Agenda
Village of Arlington Heights
Design Commission
Community Room, 3rd Floor

Arlington Heights Village Hall
33 S. Arlington Heights Road
Arlington Heights, IL 60005
April 10, 2018
6:30 PM

- A. DC#18-024 - 915 S. Dunton Ave. - SF/Addition
- B. DC#18-028 - Golden Corral - 445 E. Palatine Rd. - Commercial
- C. DC#18-026 - 4 N. Hickory Ave. - Mixed Use

Poloz Estate 915 S. Dunton Ave. Arlington Heights - IL - 60005	
Existing/Demo Exterior Elevations	
Project number	2018.100
Date	02.21.2018
Drawn by	pd Studio - DPP
Checked by	Poloz Architects - PNP
A-4.1	
Scale	1/4" = 1'-0"

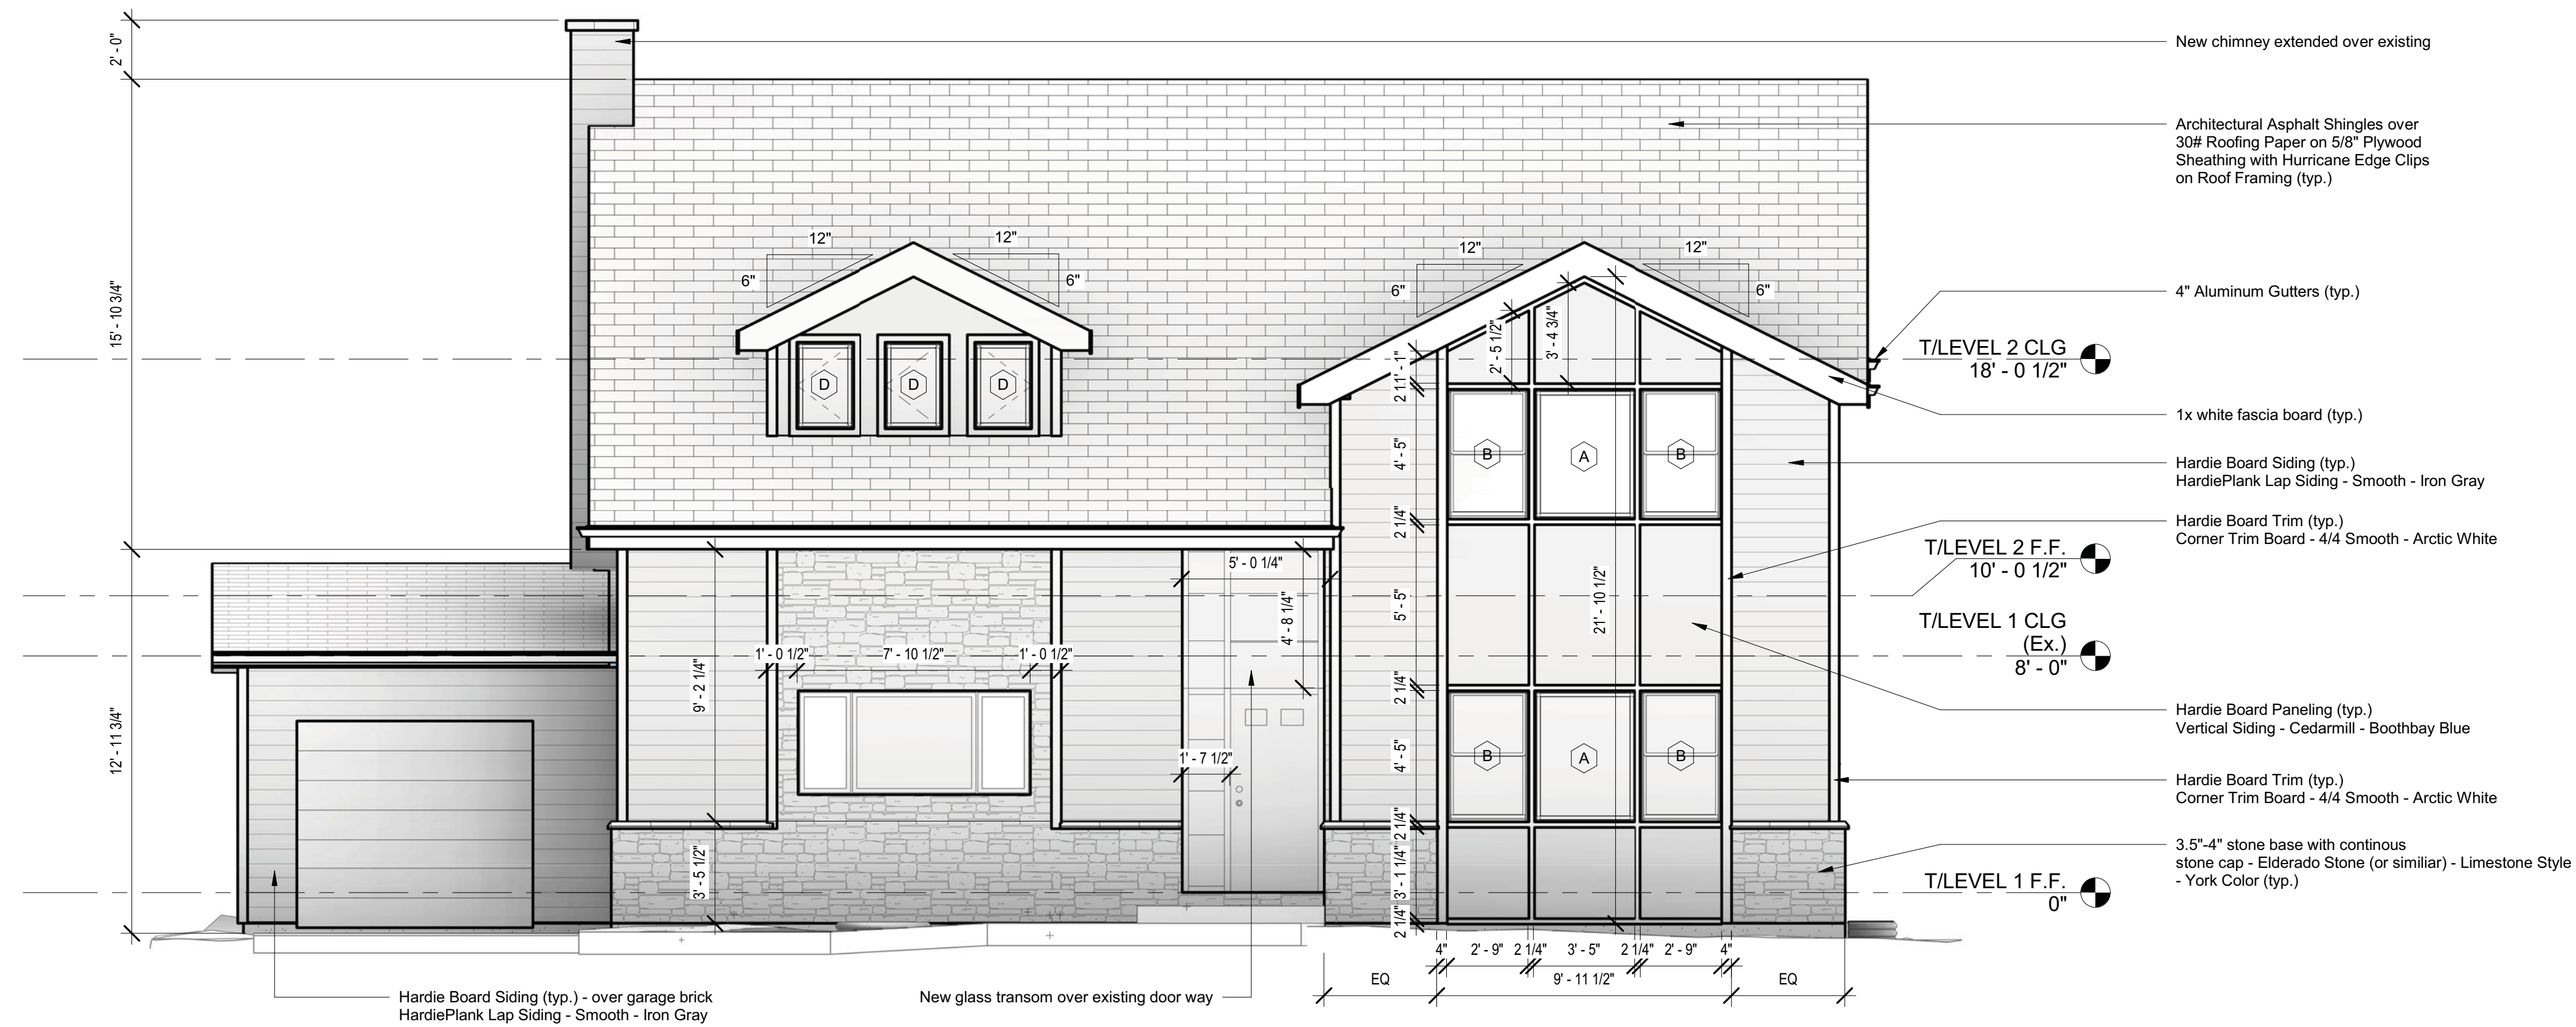
1. Adjust the roof slopes to lower the eave on the left side of the front elevation to more closely align with the existing garage eave.
2. Lower the dormer to align with the adjacent gable, and change the dormer windows to match the windows on the right side of the front elevation.

3. Change the kitchen windows to more closely match the windows on the right side of the front elevation.
4. Omit the field of stone around the kitchen window, but keep the stone base.
